ATTACHMENT A
PREDEVELOPMENT PLAN REVIEW COMMENTS TO APPLICANT

PREDEVELOPMENT PLAN REVIEW COMMENTS

Project Number: PPR2019-00015 **Date:** February 4, 2020

Project Address: 336 Saint Katherine Drive
(5704-004-007, 5704-004-008, 5704-004-009, 5704-004-010, 5704-004-011, 5704-004-012, 5704-004-013, 5704-004-014, 5704-004-015)

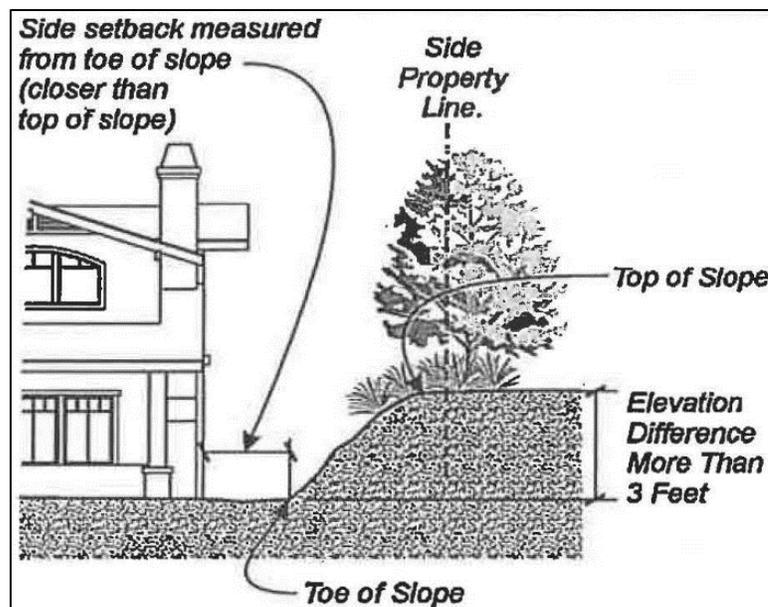
The site plan does not reference the proposed front setbacks. The line representing the 25-foot front setback and the proposed dimension shall be referenced as part of all future submittals.

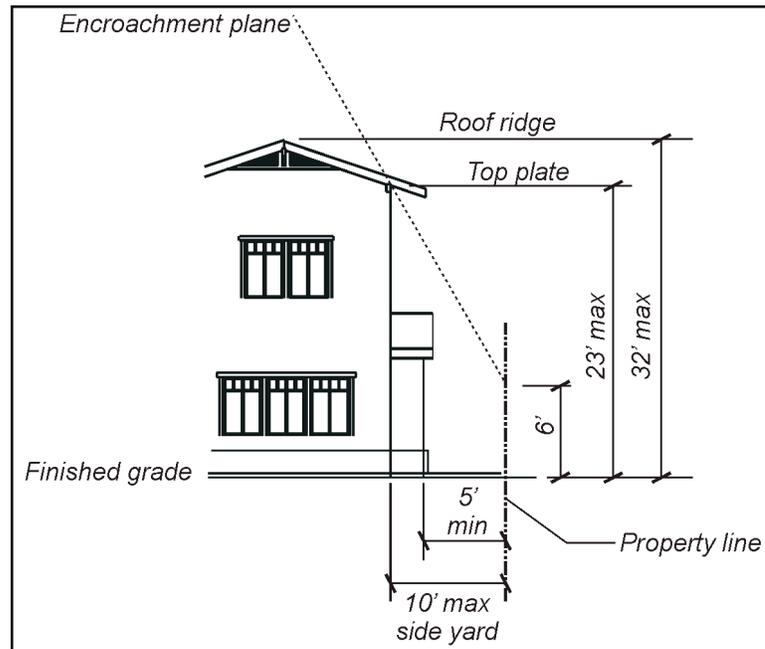
The site plan does not reference the proposed side setbacks. The line representing the 10-foot side setback, the proposed dimension, and the toe or top of slope (where applicable) shall be referenced as part of all future submittals.

Figure 2-3 – Location of Structure Below Ridgeline

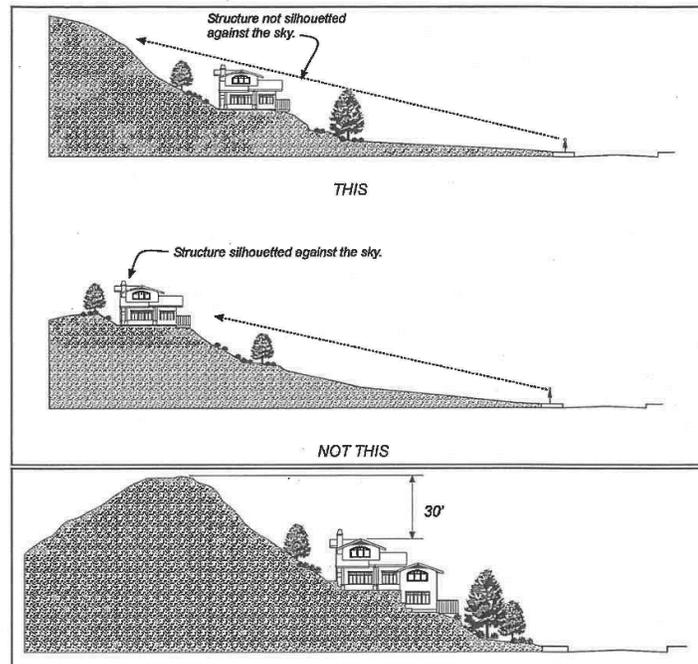
The proposed improvements are located on a hillside that generally peaks at the City's jurisdictional boundary located along the north property line of proposed Lot 1 and Lot 2. Though the proposed dwellings are positioned below the top of the mountain or hill, it is unknown whether the topmost point complies with the ridgeline protection requirements. The applicant shall demonstrate compliance as part of all future submittals.

FIRE APPARATUS TURNAROUND STANDARD
LADDER TRUCK

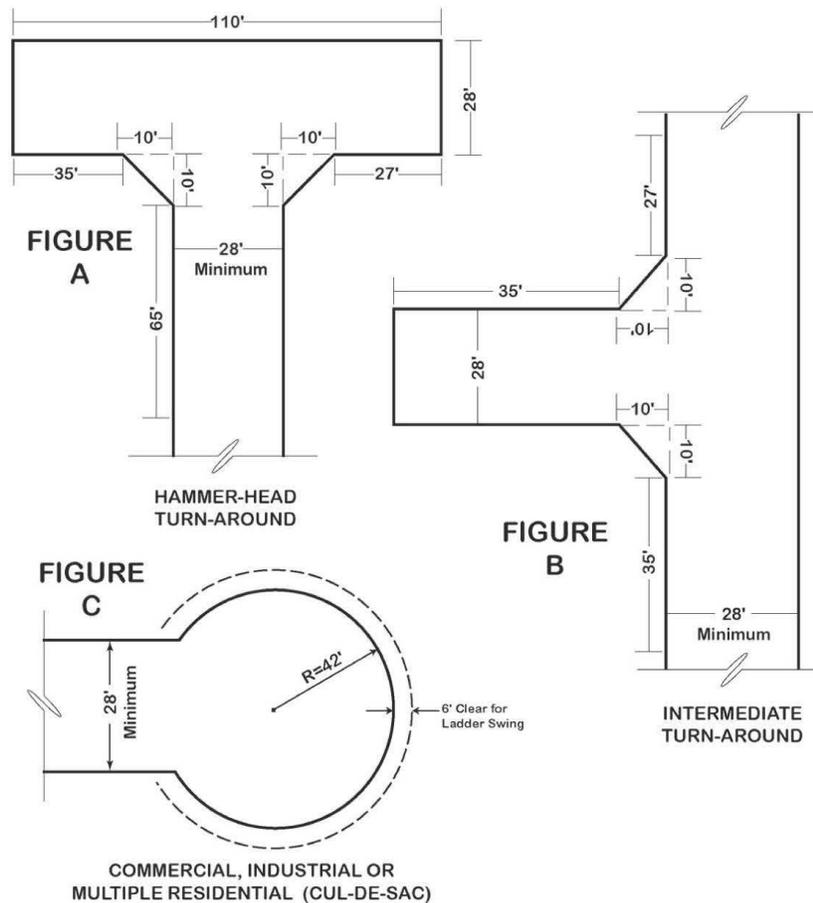
3. Fire apparatus access road shall comply with CFC 2016 Appendix D requirements. The access road shall be wide 26 feet with 96 foot diameter cul-de-sac per CFC 2016 Figure D103.1 requirements (see attached).
